1225 Dundas Street E (CPP#18913)
Pedestrian Wind Assessment – Mitigation Opinion Letter

Project Background

Figure 3: 3D Model of Development (Received 24 June 2025) (Left) and Drawing SPA161 – MPH (Received 11 July 2025) (Right)

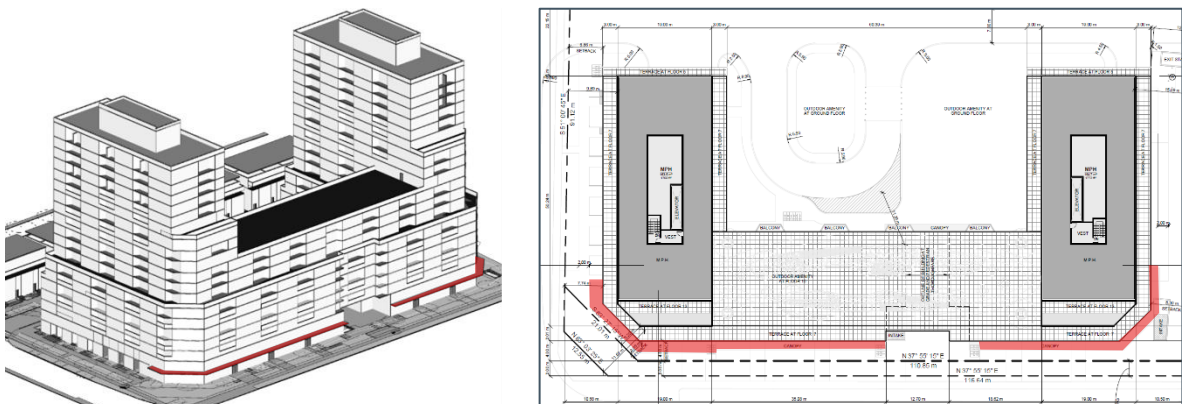
- To mitigate higher wind speeds, the team has integrated overhead canopy features which extend around the south corner of the building, along the southeast facades, and around the east corner of the building (see Figure 3). These features are to project from the façade ~1.8m except for the section of canopy that extends around the south corner which is to project ~2.4m.

- While the design of these canopy features have not been finalized it is worth noting that canopies of porous materiality would be expected to be more beneficial in providing improvement to the wind conditions in the areas below by dissipating the energy from intercepted winds as opposed to if the top

surfaces of the canopies were “solid” which may otherwise intercept and re-direct winds and lead to increased wind activity elsewhere. If a porous materiality is pursued, it is encouraged that these features be 20-30% open to be most effective.

- The inclusion of these canopy features is expected to lead to a roughly one category of improvement in wind conditions in the areas protected below (i.e. Uncomfortable to Walking, Walking to Standing etc.) but offer diminishing improvement to sidewalk areas along Arena Road and Dundas St E.

Figure 4: Drawing SPA151 – Floor 1
(Received 11 July 2025)

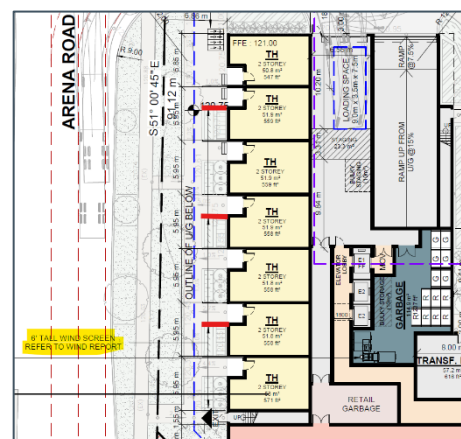
- A series of privacy / wind screens (6' tall) are to be added between the TH units along Arena Rd (see adjacent Figure 4). These features are positive and will disrupt winds which is expected to lead to more favorable wind conditions for patrons at the TH units.
- While the design of these features is still in flux, it is worth noting that screens of porous materiality (20-30% open) would be more beneficial in providing improvement to the wind conditions in the areas in lee by dissipating the energy from intercepted winds as opposed to screens of solid materiality which may otherwise intercept and re-direct winds, leading to increased wind activity elsewhere.

Figure 5: Drawing SPA151 – Floor 1
(Received 11 July 2025)

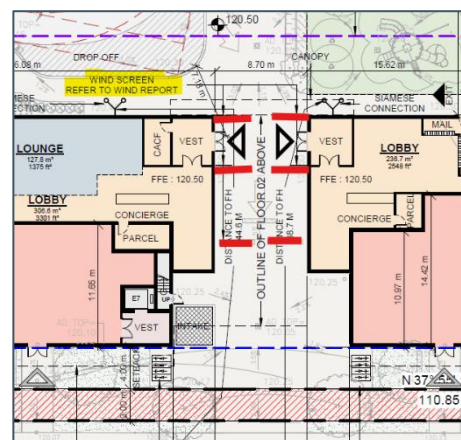
- A series of wind screens (6' tall) are also to be added in the central tunnel through the building (see adjacent Figure 5). These features are positive and anticipated to disrupt winds channeling and accelerating through the passage from both the northerly and southerly directions.
- While the design of these features is still in flux, it is worth noting that screens of porous materiality (20-30% open) are expected to provide more wind dissipation than wind baffling elements of solid materiality.
- In addition to the wind screens proposed centrally within the passage, the team has also incorporated a series of wind screen features on either side of both vestibule entries in order to protect the doors from being caught by the wind and minimizing challenges for pedestrians to open / close the doors when entering and exiting the building.

Figure 6: Predicted Wind Comfort Conditions – Summer (Left) & Winter (Middle) and Predicted Wind Safety Conditions – Annual (Right) – Level 10 Outdoor Amenity

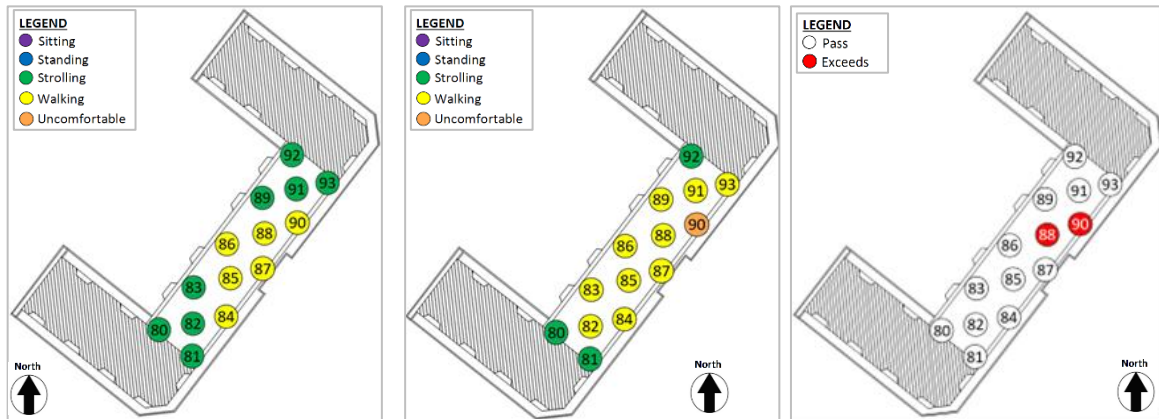
- As noted in CPP's Pedestrian Wind Assessment (and summarized in Figure 6 above) increased wind activity is anticipated throughout the main Level 10 outdoor amenity due to the overall exposure to approaching winds as well as a component of winds which intercept the towers, down-wash and flow throughout the terrace.
- The programming of the Level 10 outdoor amenity is primarily a walking track around the perimeter with several seating areas sited on the long ends closer to the towers (see Figure 7 for reference). The wind conditions throughout the amenity during the warmer summer months are already considered suitable for use as a walking track.

Figure 7: Drawing SPA157 – Floor 10 (Received 11 July 2025)

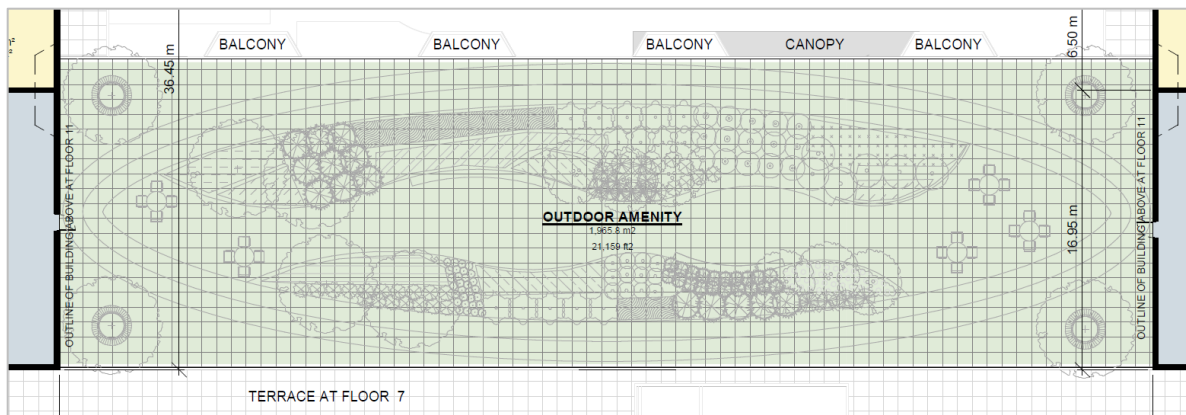
- Although the mix of trees and dense underplanting's centrally within the space are expected to assist in disrupting winds (particularly during the summer / warmer months when the space is to be used most frequently), the seating areas on either side of the amenity are likely to be more wind exposed and less favorable for seating / dining.
- CPP encourages the team to consider localized wind protection elements (i.e. wind screens trellis features, etc.) around these spaces to provide additional shelter from approaching winds.
